From: Ken Polner
To: ken@bentoncountyspokane.com
Cc: ken@bentoncountyspokane.com; ken@bentoncountyspokane.com
Subject: Comments for the New Staff Report on LU-24-027
Date: Tuesday, October 1, 2025 4:08:23 PM
Attachments: [Exhibit 85 \(revised\) ARB Fall Jan 2025.pdf](#)
[BCL ARBQ 09112025.pdf](#); [BCL PC Decision on comments of evidence SUBMISSION.pdf](#)
[BCL ARBQ 09112025.pdf](#); [BCL PC Decision on comments of evidence SUBMISSION.pdf](#)

I'm writing to advise you on what to look for in the new Staff Report, prepared for your *de novo* Hearing on the appeal of the Planning Commission's Decision to Deny LU-24-027, the application to expand Coffin Butte Landfill. By including your Staff on this mailing I'm also advising them on what to consider and include in that Staff Report, which they have committed to releasing eight days from now.

Appeal of Planning Commission Decision: Responses and Additional Evidence

Figure 1 Measured PPV and Vibration Propagation Curves

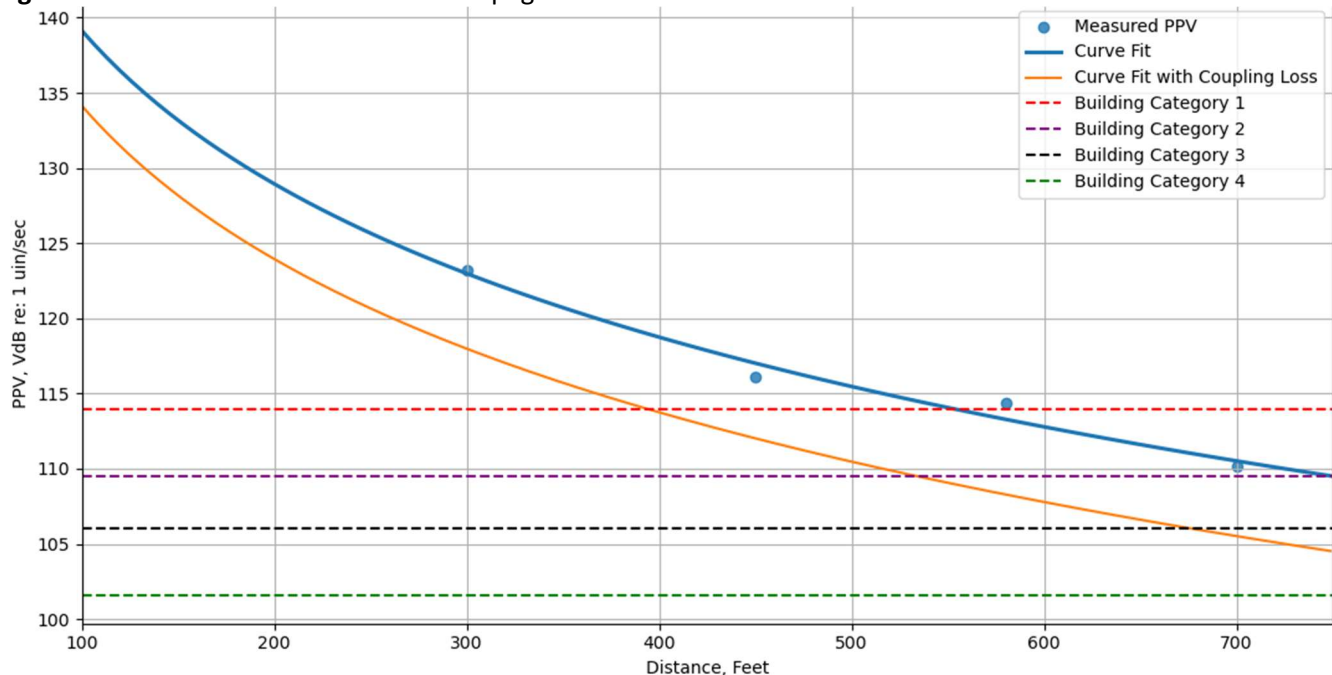
Noise pollution and heavy truck and waste hauling traffic has been a persistent complaint topic regarding current operations of the Coffin Butte Landfill. The expansion application did not address noise concussions, increased heavy truck traffic to remove 2.1 million cubic yards of blast material from the expansion site, and other heavy equipment noises and impacts for the construction of the expansion area, including removal and mitigation of the current leachate ponds. The combined adverse impacts, undue burden and serious interference of the region due to the noise and traffic increases of the combined current operations and the expansion area were not addressed, including any reasonable mitigation to the region or surrounding properties proposals by Republic Services.

Vibration levels from blasting within the expansion area are anticipated to be less than those measured within Cell 6 and therefore the levels shown in Figure 1 would likely be lower. Reduced vibration levels will likely result from the use of smaller charges within the expansion area. Additionally, vibration propagation was measured through rock that was exposed in Cell 6. The foundations of structures situated near the expansion area are unlikely to be within the same hard subsurface as blasting and therefore vibration propagation between the rock being blasted and the looser surface soils would reduce vibration levels received at the structures.

In conclusion, construction noise is anticipated to be up to 5 dB louder than typical existing daytime levels, which will not result in any significant noise effects. Sound from blasting is predicted to be 10 dB quieter than the sound limits for blasting identified in the OAR, which is approximately half as loud as what is allowed by Code. Vibration from blasting is not expected to affect any existing structures within 675 feet of the center of the blast site, therefore no structures will be affected.
